TECHNICAL NOTE			
from:	ALAN DAVIES	date:	24/3/2018
subject:	18F/0417 PROPOSED RESIDENTIAL DEVELOPMENT WHITTLE STREET LIVERPOOL	file ref:	J914-TN1

A reply has been received from highways raising a number of areas for clarification. This Technical Note sets out the response to the feedback.

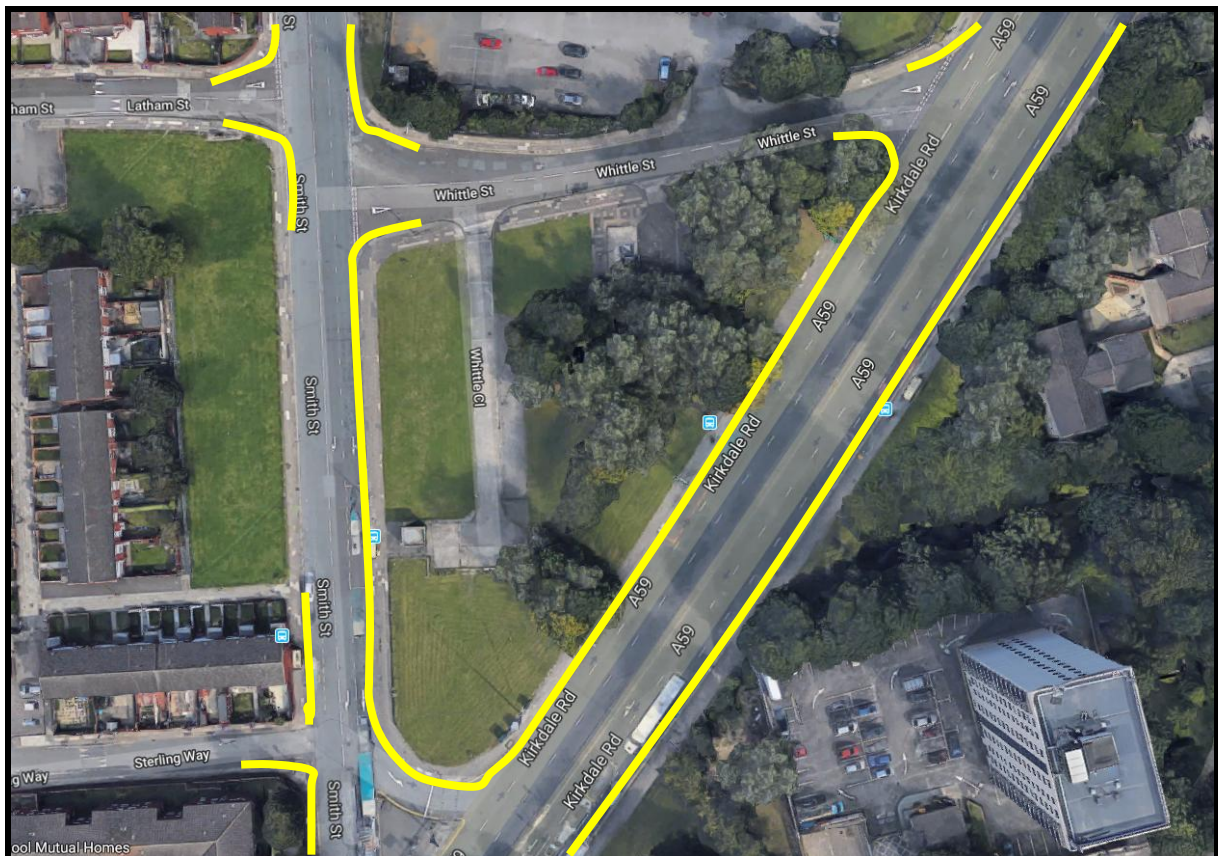
The question arises what if some overspill or visitor parking takes place on street and would it be to the detriment of road safety and amenity.

To assist the diagram shows the existing parking restrictions, there is a total ban on Kirkdale Road so no over spill can take place on the Primary route network thus the concerns falls away.

Smith street junction and bus stops are also protected by no waiting orders. On street parking occurs on the west side with no observed issues arising. The street has around 1000vph in the AM and 1400vph in the PM two way around a third to a half of the Kirkdale flows.

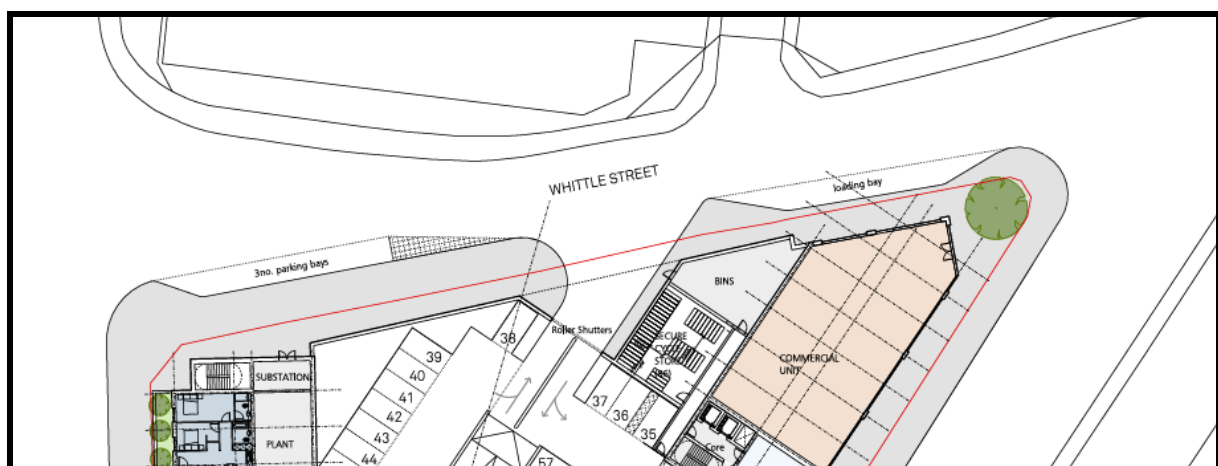
The plan shows a number of amendments to the adopted highway, in the form of on-street car parking laybys and delivery/loading bays. The location of these bays do not seem to take into account the location of existing bus stops adjacent to the site, and would conflict with their continued operation. The loading bay on Whittle Street does not seem to be able to be accommodated within the current highway layout without reducing the adjacent pedestrian footway to an unacceptable width. Again this should be reconsidered. The submitted plan also shows trees being planted within the highway.

Layout has been refined to accommodate the existing stops with no changes needed. A 2m path is shown to the rear of the lay bys to allow walkers to pass by. The land will be dedicated as part of the formal s278 works/agreements.

The trees have been removed from the highway.
